Record of Decision Amendment

Operable Unit 2 (Deposit DD), Operable Unit 3, Operable Unit 4,
and Operable Unit 5 (River Mouth)

Lower Fox River and Green Bay Superfund Site

June 2007

Figure 1: Water Temperatures of the Namekagon River (USGS 2006)

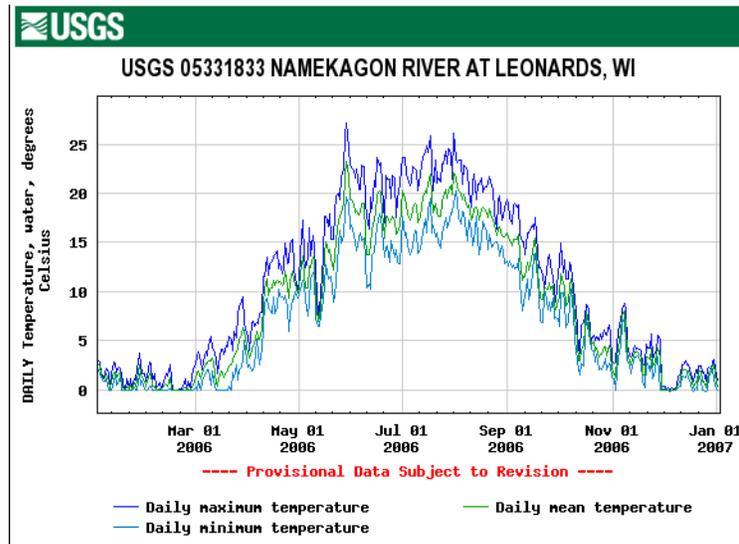
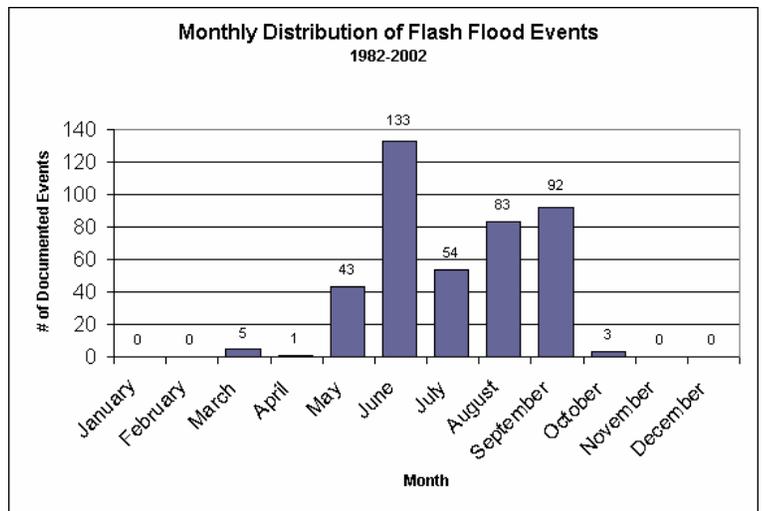
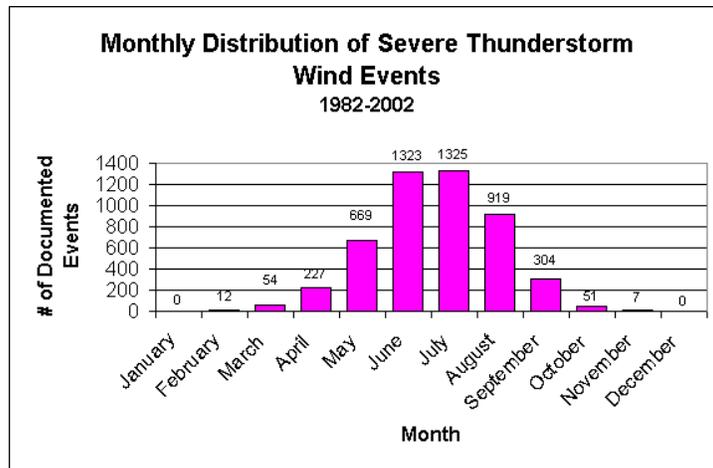
A review of the historical data shows that the analysis performed by Ashton on ice formation (2005) is cursory and incomplete. None of the conclusions are statistically verified, and fail to account for more extreme freezing events. The coldest temperature considered in the analysis is -5° F, while record lows of -20° and below have been recorded a number of times during the winter months. The analysis also does not investigate the effect of ice jams on additional ice formation in the areas behind the dam. It is unclear if such jams could result in ice impacting areas with caps.

Flooding is also a significant threat to caps in the Fox River. As shown in Figure 2, significant precipitation events and therefore discharges in the Fox River over the past 20 years occur mainly from May to September, with the greatest number of previous flash flood events recorded in June (NWS). The largest recorded discharge (33,800 cfs) recorded at the mouth of the river also occurred in June over sixteen years ago. Data were obtained from the USGS water database, which is available on the internet at <http://waterdata.usgs.gov/nwis/sw>. Attempting to determine average discharges at the mouth of the river from USGS data is difficult as the agency appears to only take data from this station sporadically.

Data have been collected more regularly from a station in Wrightstown which has recorded 2 events approaching the 100 year flood estimate of 24,200 cfs used in the BODR (USGS). The station is located at the Rapid Croche Dam, which according to the USGS may influence discharges because of flow restrictions and other dam related activities. However, according to Figure 1-1 of the BODR this location is approximately 22 miles from the mouth of the river (Shaw, 2006). The two events in 1952 and 1960 had discharge rates of 24,000 and 23,600 cfs respectively. Locations downriver have experienced even greater discharges. One instance in 1990 caused a discharge of 33,800 cfs, and the same event caused a flow rate of over 46,000 cfs at the mouth of the East River as it flows into the Fox River (Baumgart, 2007, see attached figure). These high flow rates were caused by a combination of heavy rains and a powerful seiche. A seiche occurs when strong northwesterly winds build up water in the bay, which alters water levels and flow rates. The above data indicate that flood events of the calculated 100 year flood magnitude occur much more frequently than estimated, and wind can play a role in these events.

The above data indicate that caps in the Fox River have a high risk of being compromised by scour events 10 months out of the year. The potential for ice related scours is high though the winter months, and through the summer and early fall flood events become a significant concern. Placing a cap in such a high risk area is completely unacceptable.

The Agency agrees with the technical concerns for the impact of ice jams and/or frazil ice on locations chosen for capping in the Amended Remedy (ice jam potential discussed above). In Attachment D to Appendix D of the BODR in a report entitled, "Effects of Ice on Sediments in Fox River Near Green Bay, Wisconsin," by George D. Ashton, Ph.D., July 10, 2005, it was concluded frazil or anchor ice formation could form in the 1 ½ miles of river in OU3 below the Kaukauna Dam, and the first 1400 feet of river below the De

Pere Dam in OU4. Therefore, no capping will be done in those areas. Dr. Ashton concluded that there were no areas in OU3, OU4, or OU5 that are likely to experience ice jams, as discussed in the preceding comment response. Dr. Ashton based his observations both on the United States Army Corps of Engineers database, and local reports.

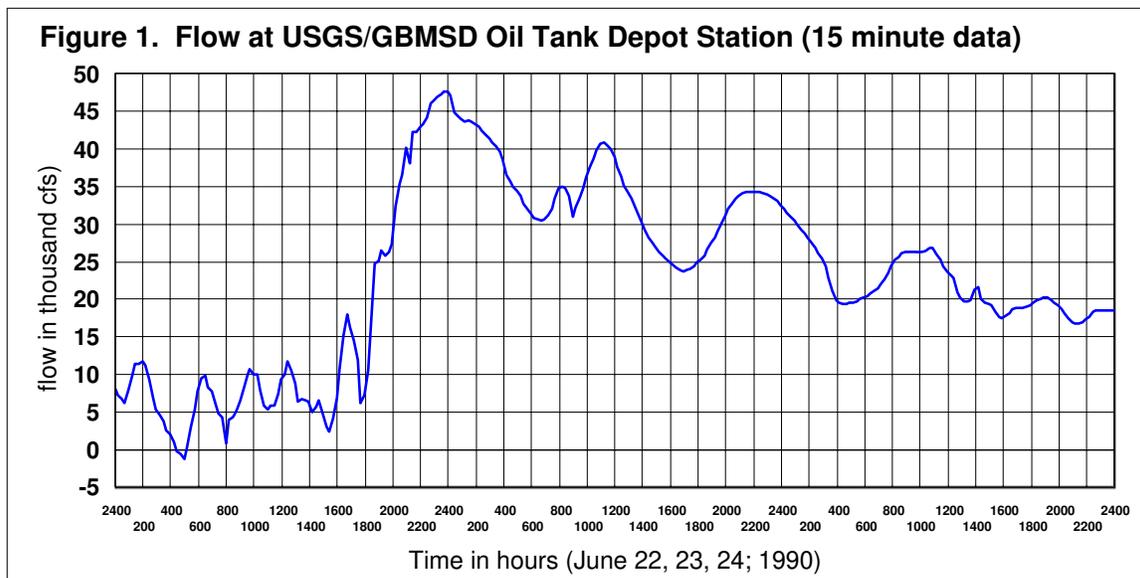
We strongly recommend against this change. The increased risk of leaving “hot spots” in the river, in our opinion, far outweighs the marginal cost savings. Throughout the earlier planning efforts, it was acknowledged that riverine sediments with higher PCB concentrations posed the greatest risk to long term contamination of the Bay. At the same time, it was shown that dredging high concentration areas provided a cost effective means of removing PCB mass from the ecosystem. Therefore, we see no reason to modify the original ROD guidance on this issue.

The only locations where PCBs above 50 ppm would be capped are areas in the navigation channel where contaminants are deeply buried and in near-shore areas where shoreline stability would be in question. In these locations there would be some dredging and then capping with thicker sand, and larger armor stone (preliminary designs call for 15-inches of sand and 18-inches of large stone). Thus, the cap over these deeply buried, higher level PCB sediments would be especially stable and robust. It is highly unlikely that these deeply buried sediments would be subject to erosion or re-exposure, particularly because these areas would have a thicker cap with larger armor stone. In areas where the PCBs are nearer the surface, with higher PCB concentrations, or in areas more subject to erosion or disruption, dredging would be done.
